TOWN OF GLASTONBURY
GL-2016-14 - GHS POOL UPGRADES
ADDENDUM NO. 1
December 8, 2015

Clarifications: The remainder of this addendum consists of three (3) drawings:

4 FLOOR PLAN

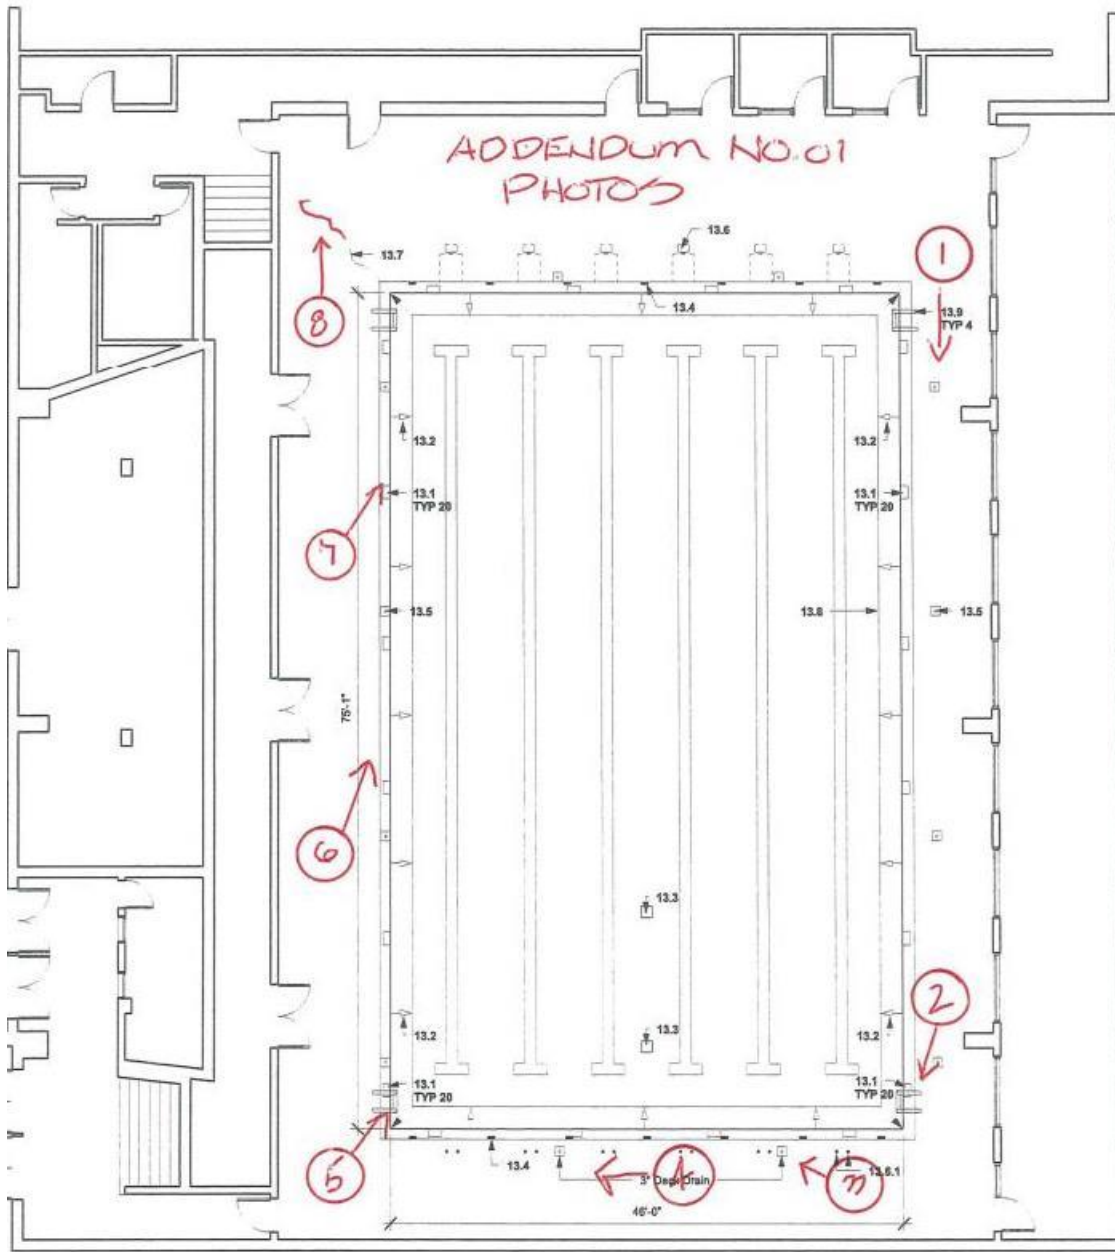
Drawing A100 Key Noted No. 13.5 The following photographs further identify the areas of tile replacement.
